## TO ALL BIDDERS OF RECORD:

This Addendum forms a part of the Contract Documents and modifies the Drawings and Project Manual as hereinafter indicated.

Project  
**DEDHAM-WESTWOOD  
WATER DISTRICT**

Storage Facility and  
Site Improvements

## SNOW FENCE (SKA-3 ADDEN. #4)

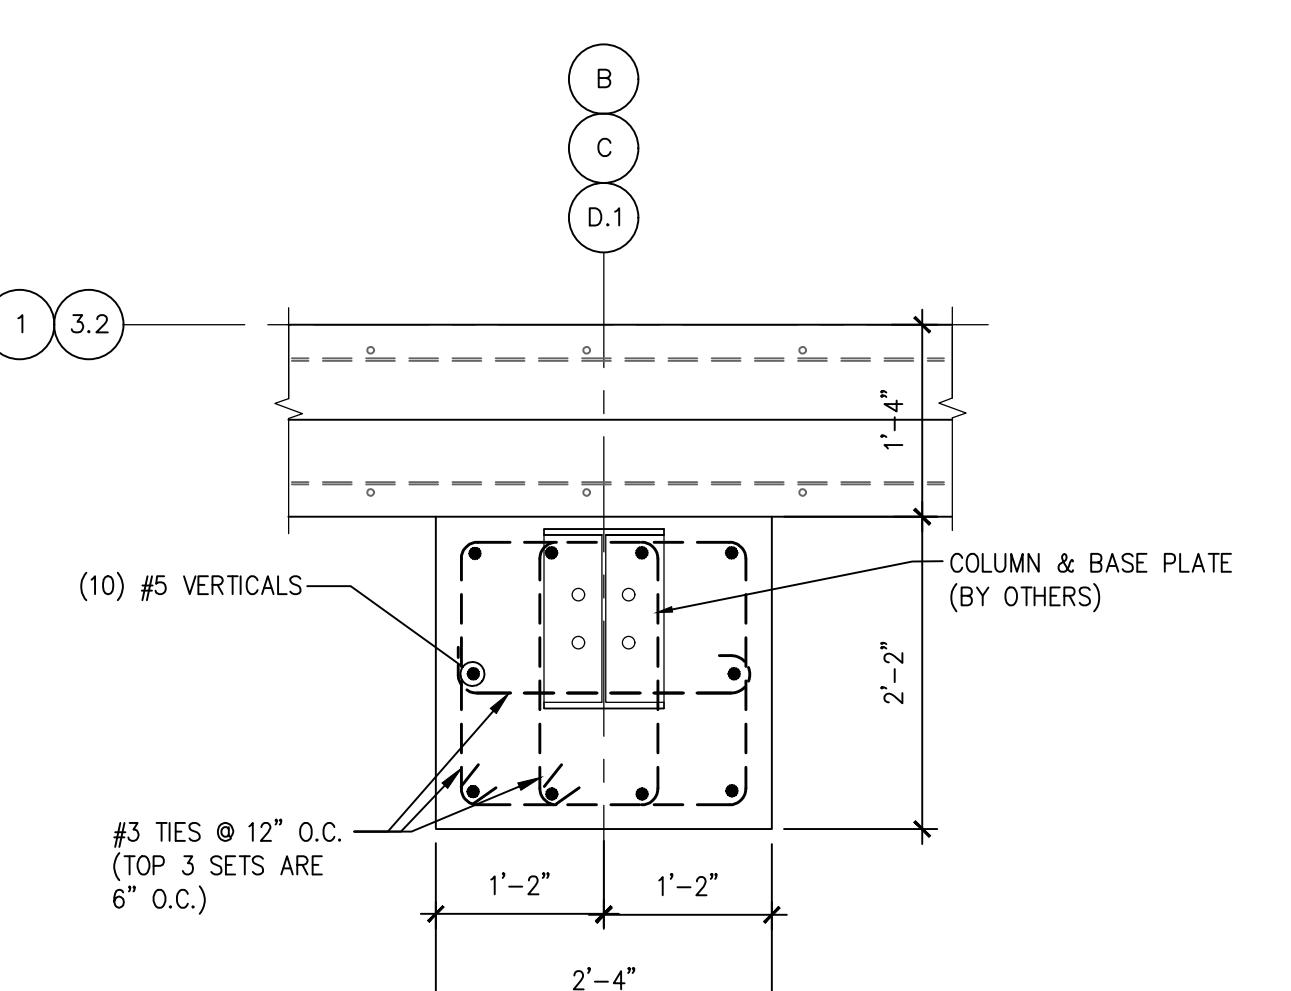
7. *Please confirm that detail 8 on drawing A500 applies to this project. The plywood/blocking shown in this detail are not typical for insulated metal panel roof designs.*

**Response: Omit 8/A500 and replace with issued sketch, SKA-3, as part of this addendum.**

CANTILEVER CANOPY CONNECTION DETAILS

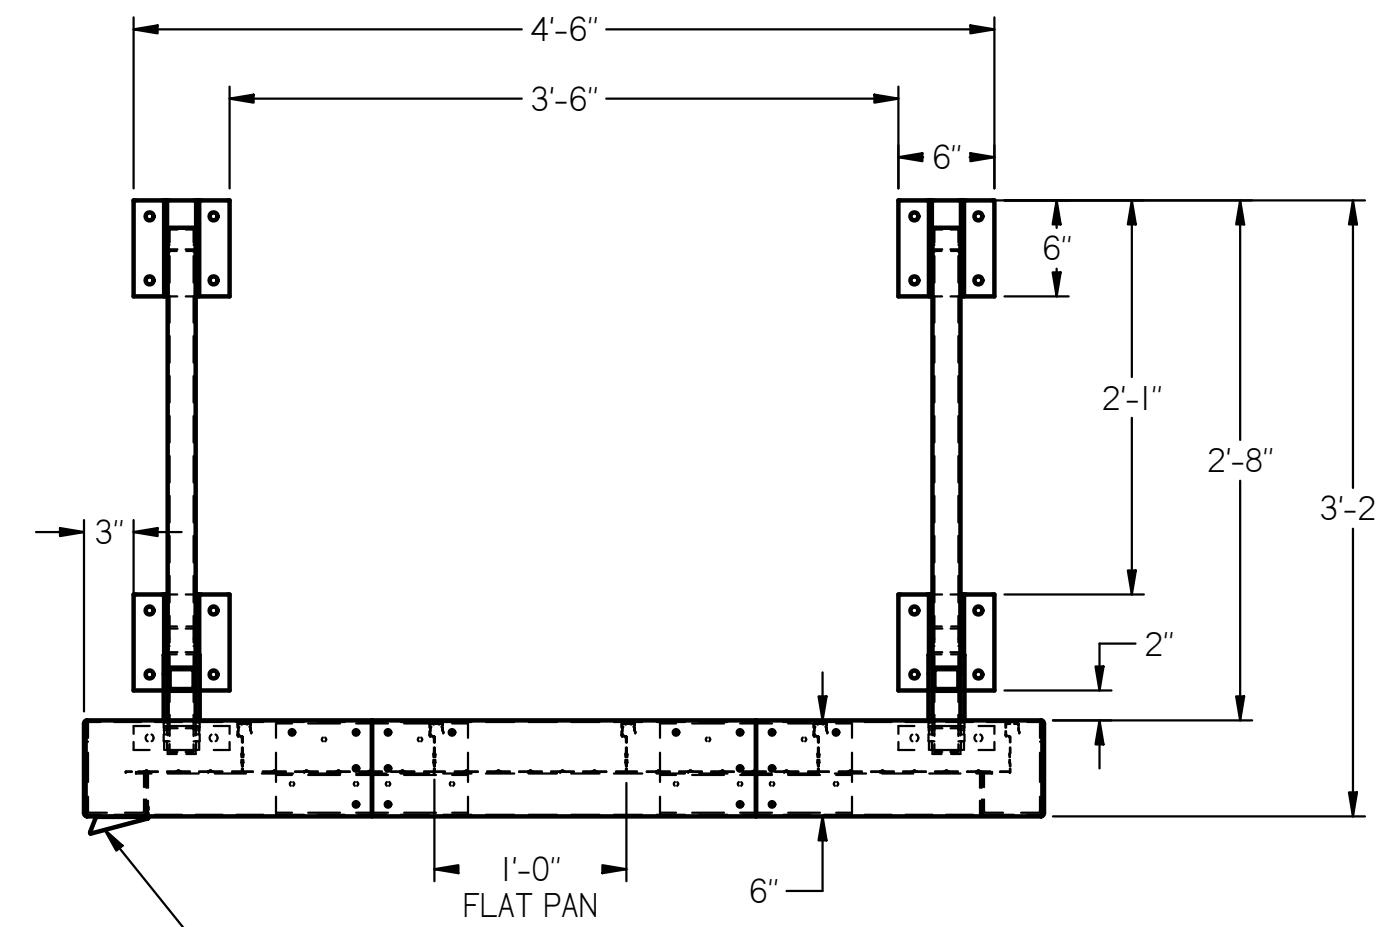
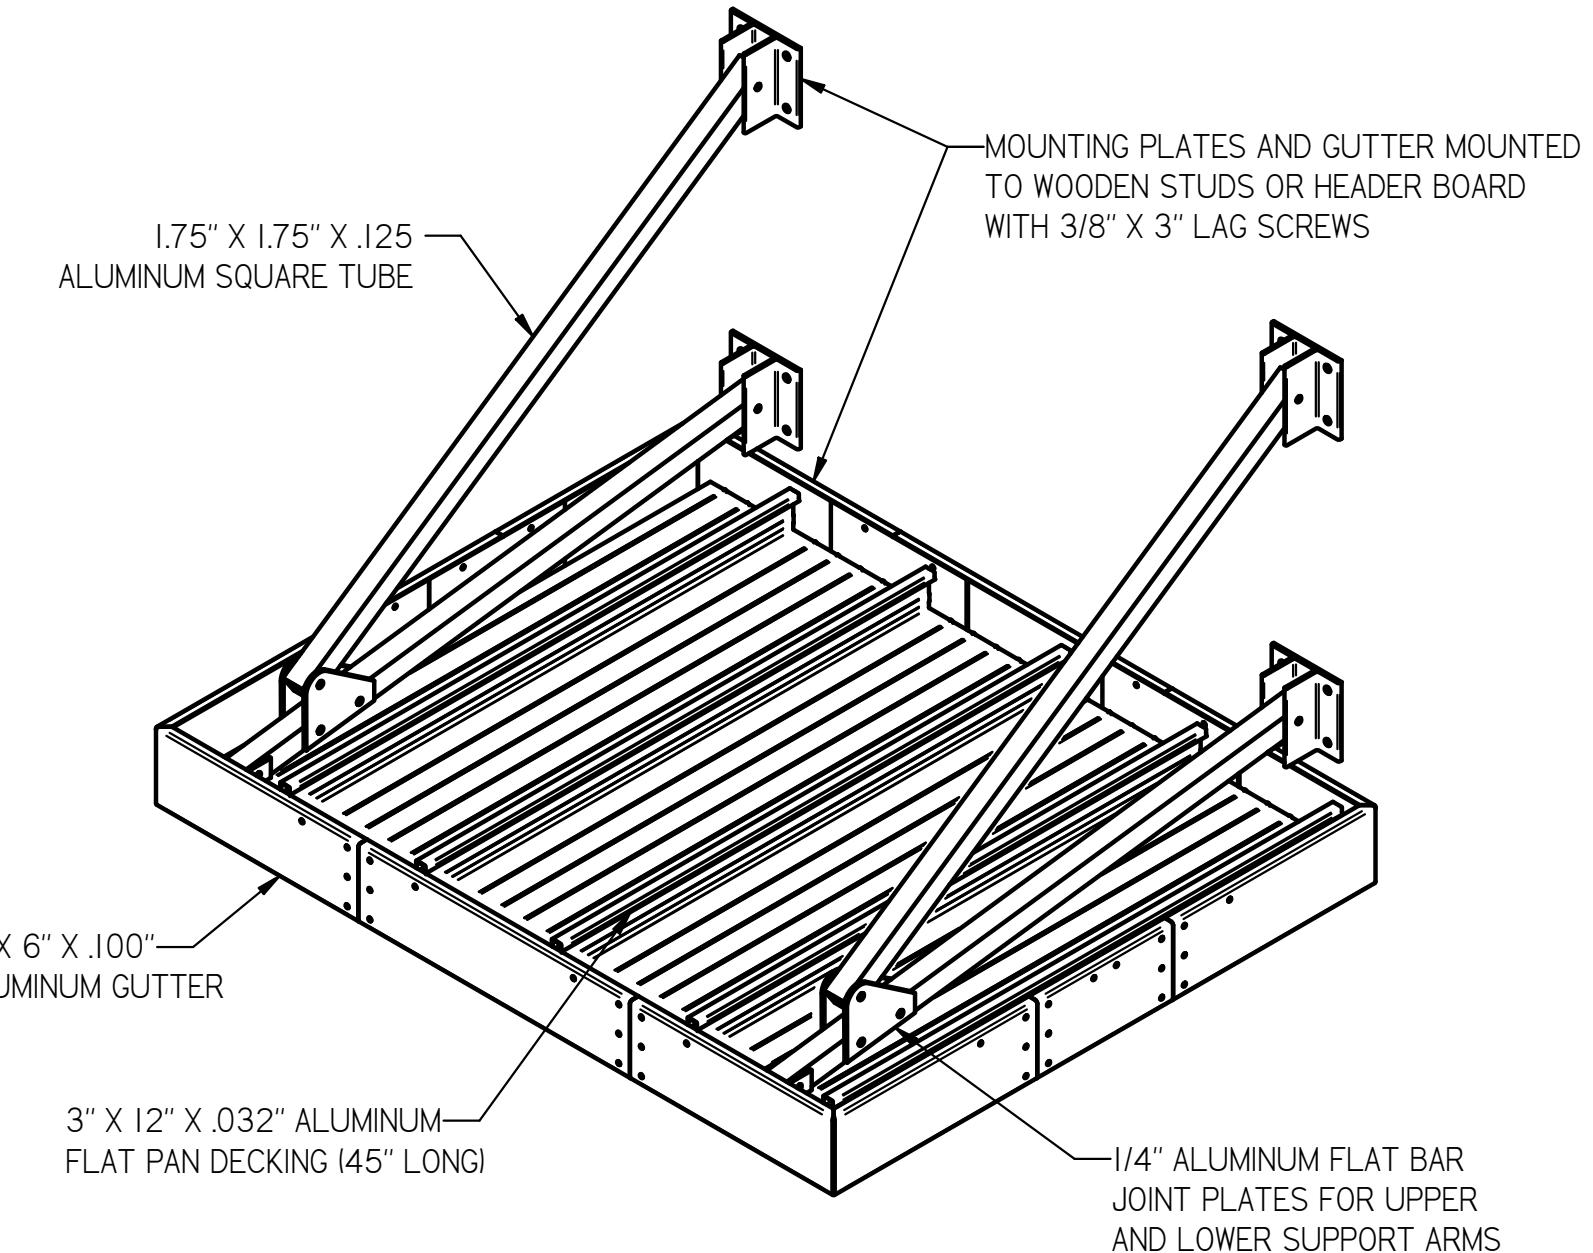
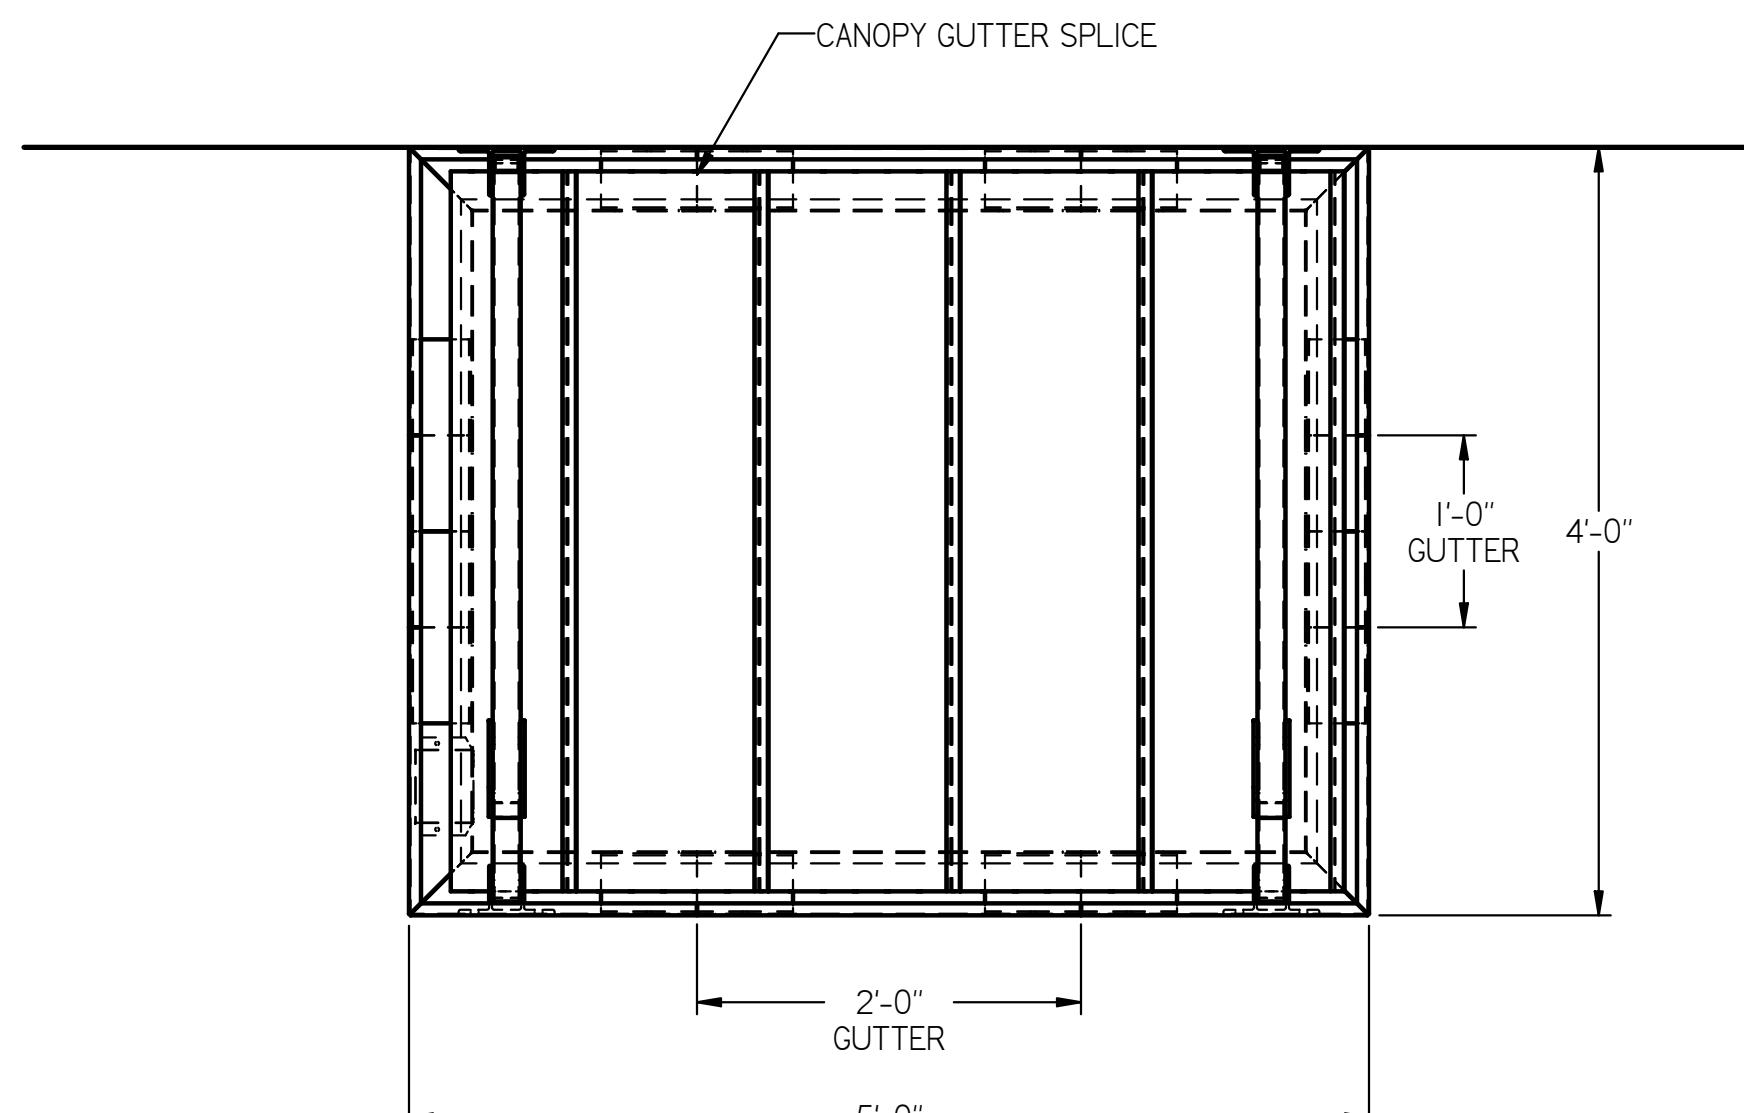
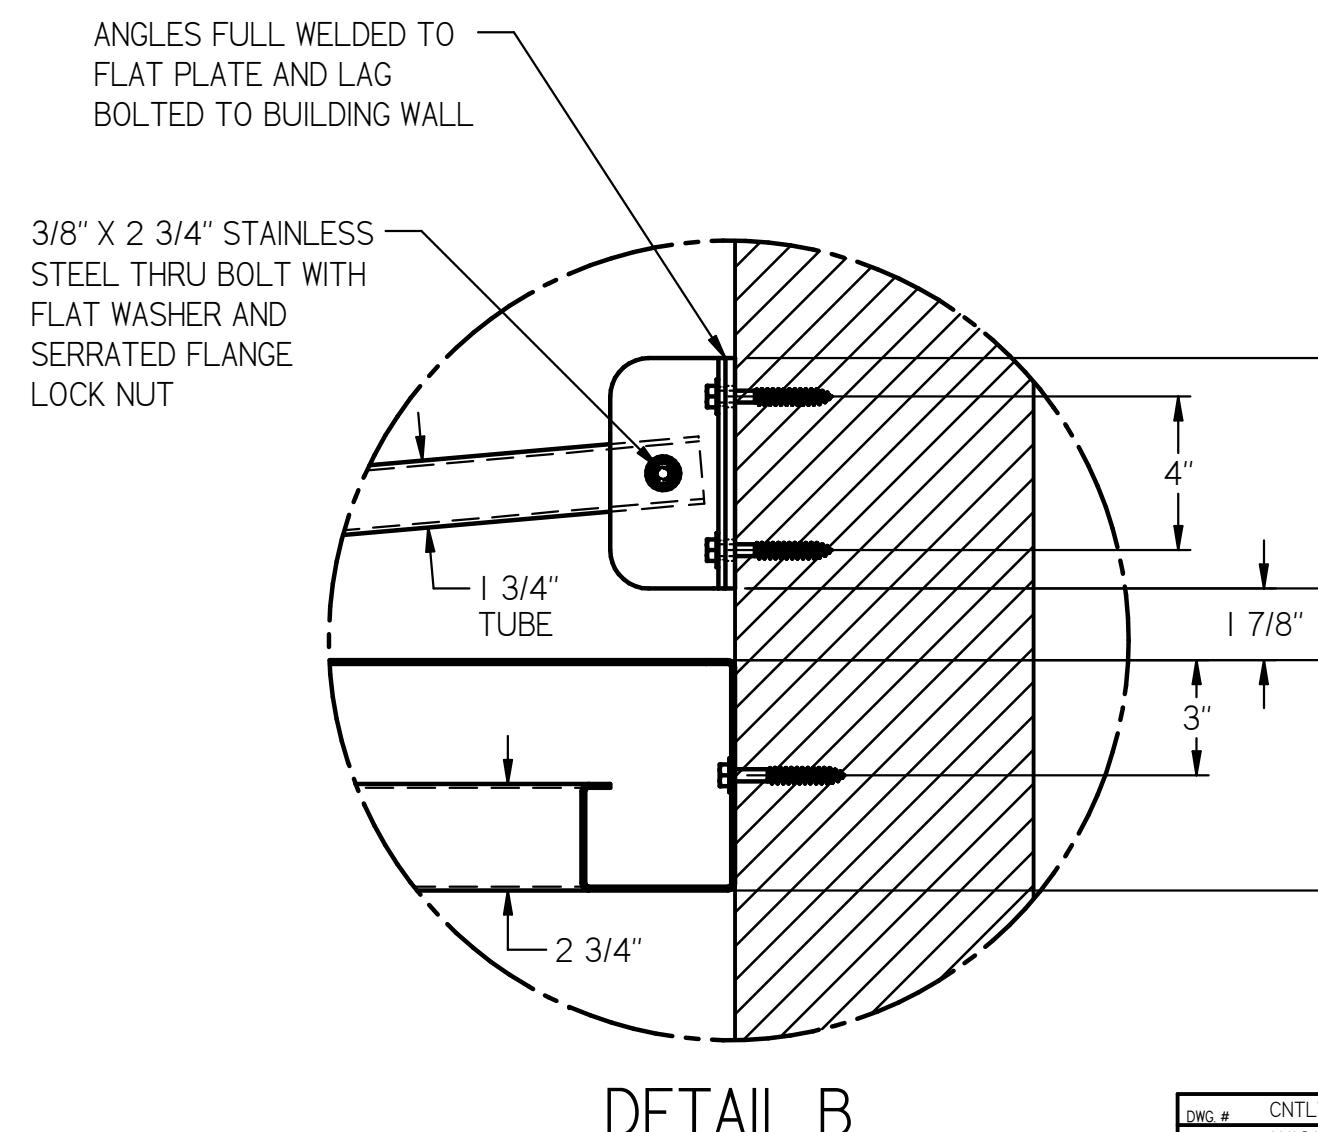
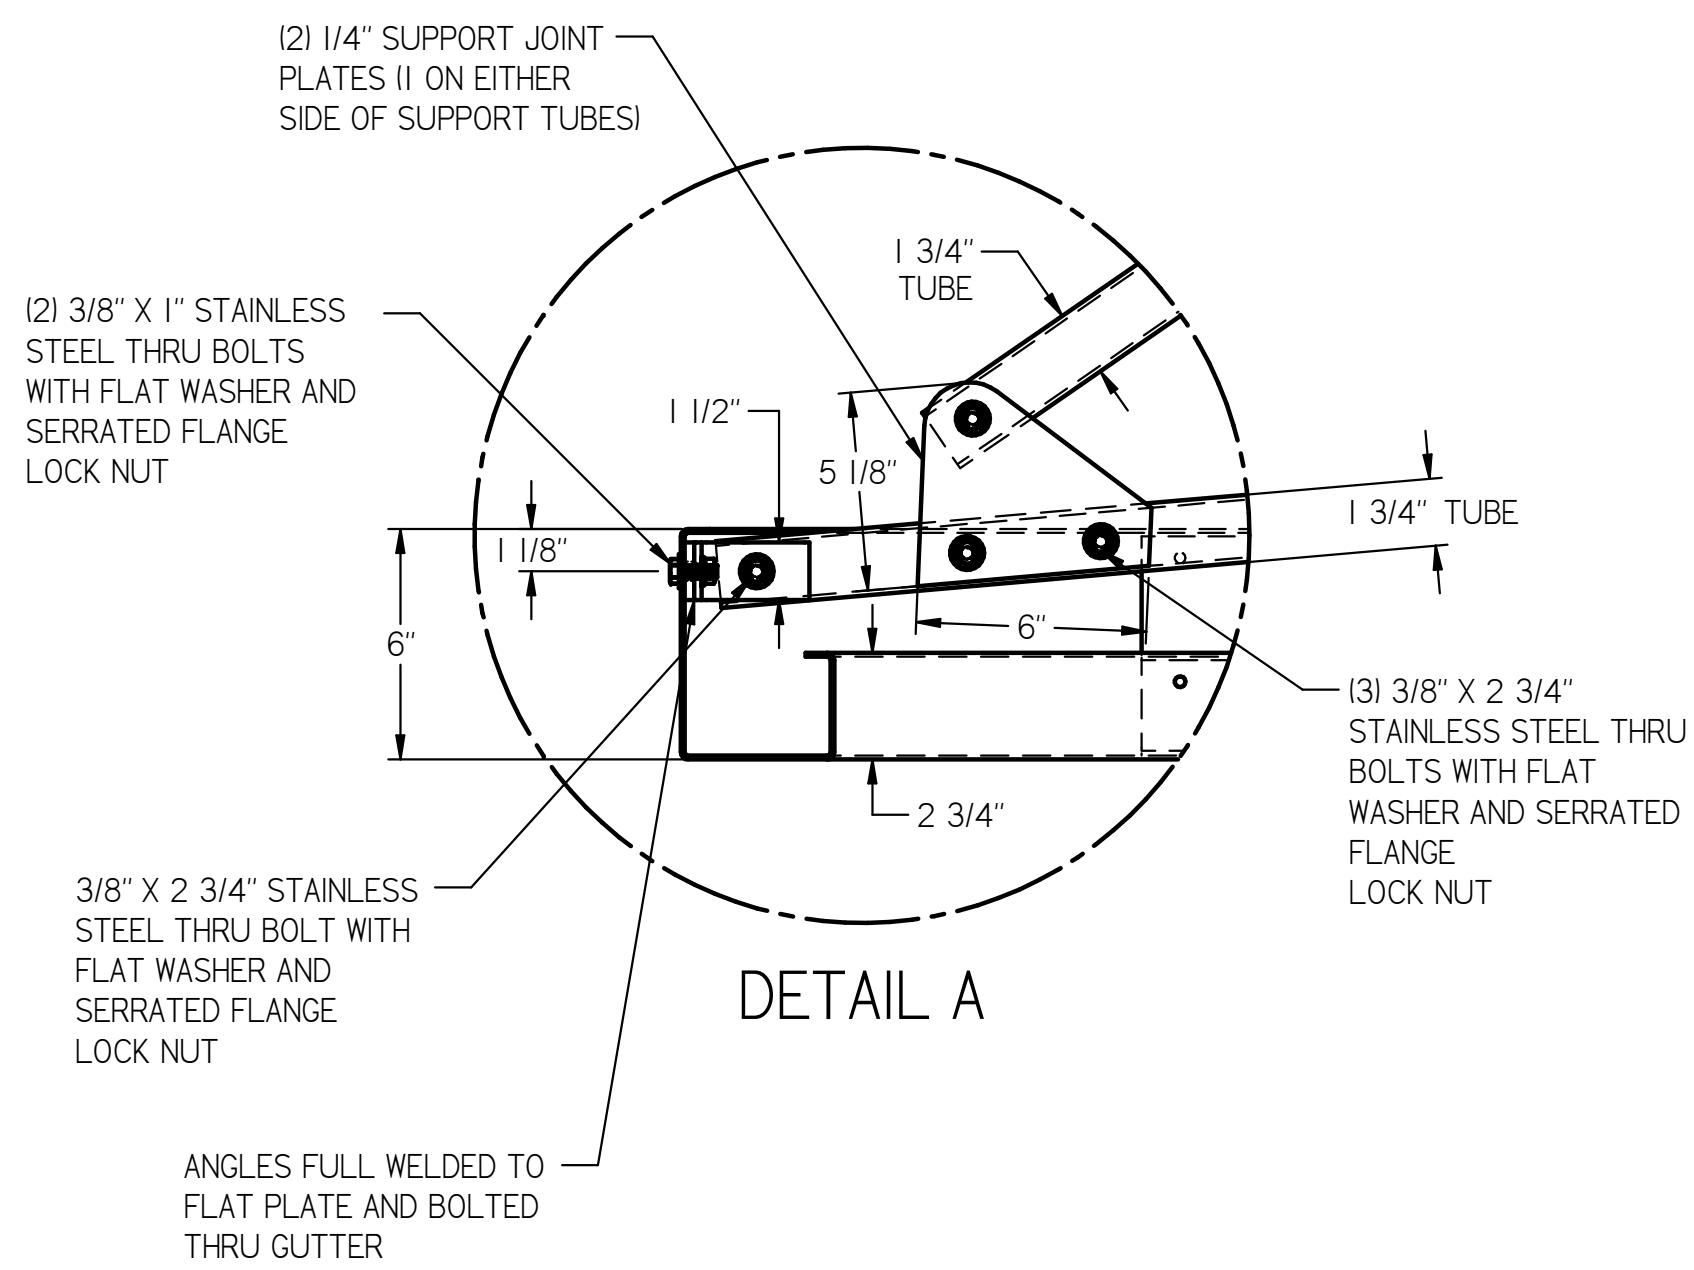
8. *Dedham-Westwood Water District prefabricated canopies. The spec section 05-9995 Prefabricated Canopy calls for two canopies that are supported by one pair of hanger rods. The*

*attached alternate product from Upside Innovation has two pairs of hanger rods. Will it be acceptable to carry this product in our base bid? Please confirm.*

**Response: This substitution for Upside prefabricated canopy is acceptable. Product documentation is included as part of this addendum for review.**
